North Little Rock Planning Commission
May 9, 2023 - Agenda / Public Hearing 4:00 PM
City Council Chambers – 300 Main Street, NLR, AR 72114

SD2023-33 – Indian Hills Lot 1A, Blk 100, (SPR for a new oil change building @ 6907 JFK Blvd)

PROJECT NO: M-7022043
 DESIGNER: PCW
 CHECKED BY: PCW
 DATE: 04/19/23
 SHEET NO: C 100
 SITE PLAN

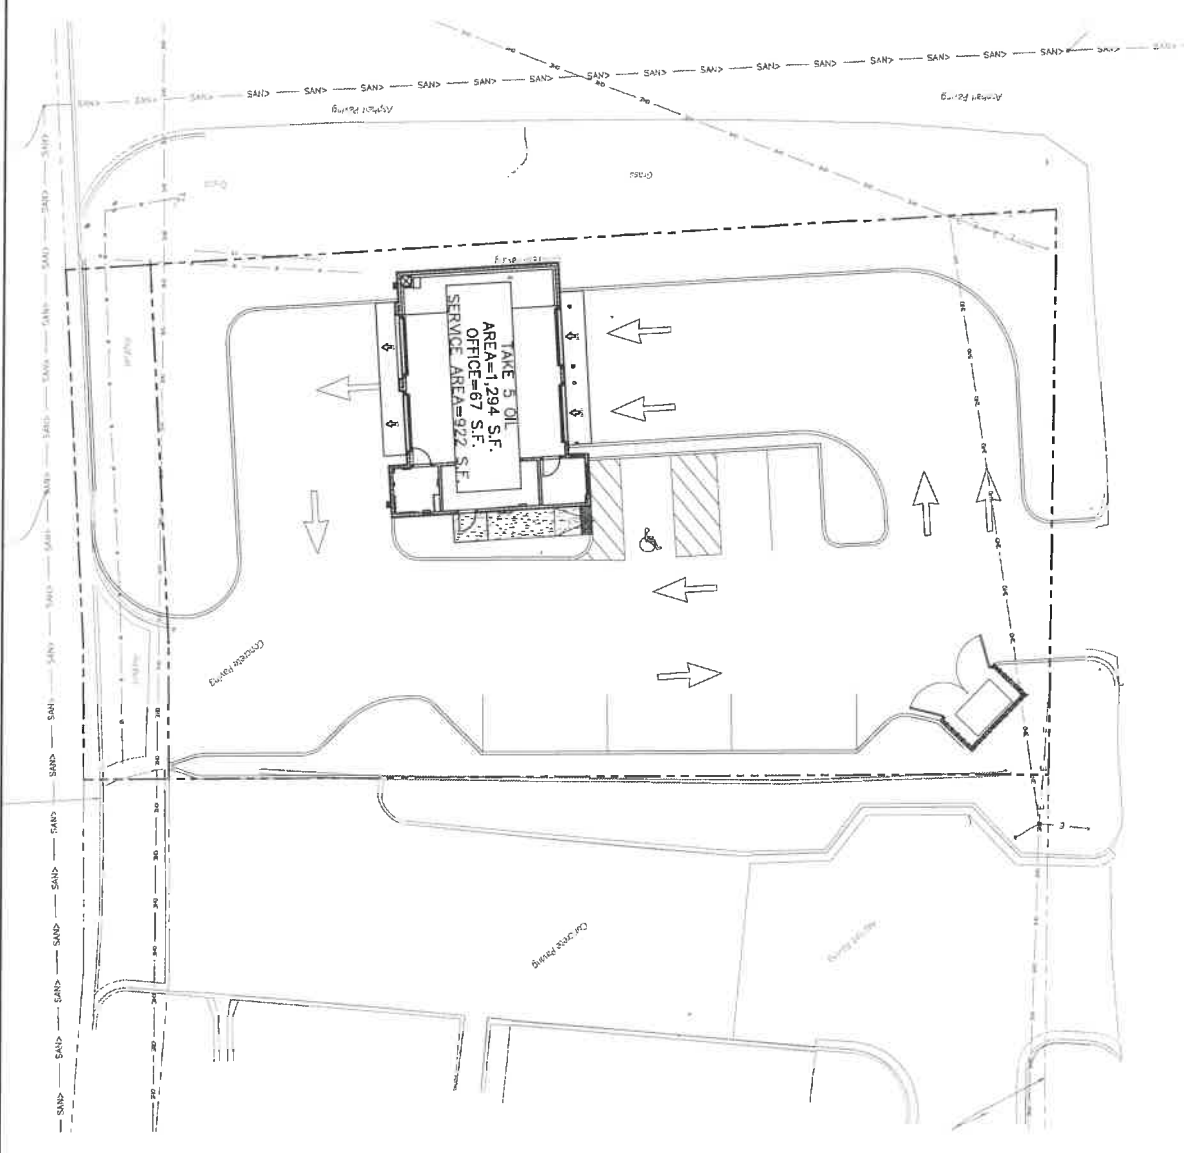
1. Provide a 8 ½ x 11 of the site development plan removing all easements, key notes and site legend items with the exception of the property lines.
2. Engineering requirements on detention:

- d. Show and label boundary of detention area as a drainage easement.
3. Permit requirements/approvals submitted before a building permit will be issued:

- h. Driveway widths shall be labeled and shall be 10' minimum to 40' maximum.
 - i. Provide a separation and clear distinction of driveway on the southern side of the site. A spacing waiver will need to be requested in order to waive the 40' requirement between driveways.

5. Meet the requirements of Community Planning, including:
 - a. Provide the standard requirements of Zoning and Development Regulations.
 - b. Provide a minimum of (6) on-site parking spaces.

- c. Provide the square footage of the office area and the square footage of the service area.
 - d. Dumpster to have masonry screening on three sides with an opaque gate enclosure.

- c. Provide screening shrubs between the vehicular use area and JFK Blvd ROW. Only shrubs from the approved planting list will count toward this requirement, unless approved by the Planning Commission. Shrubs shall be (18") in height at planting and be planted a maximum (3') apart.

- e. Provide a minimum of (1) tree in the parking area. Trees shall be planted at the rate (1) tree per (6) parking spaces. Parking lot trees are to be chosen from Table B or C, Section 7.5 of the North Little Rock zoning code, Table D shall be used if beneath overhead power lines.

- f. Provide (3) street trees (30') on center along JFK Blvd. Street trees are to be chosen from Section 7.5 of the North Little Rock zoning code. Trees from Table B shall be spaced every (30') to achieve the

- g. Provide (4’) side and rear yard landscape strip between property line and paving. The dumpster and the eastern parking space are encroaching into the required landscape strip.
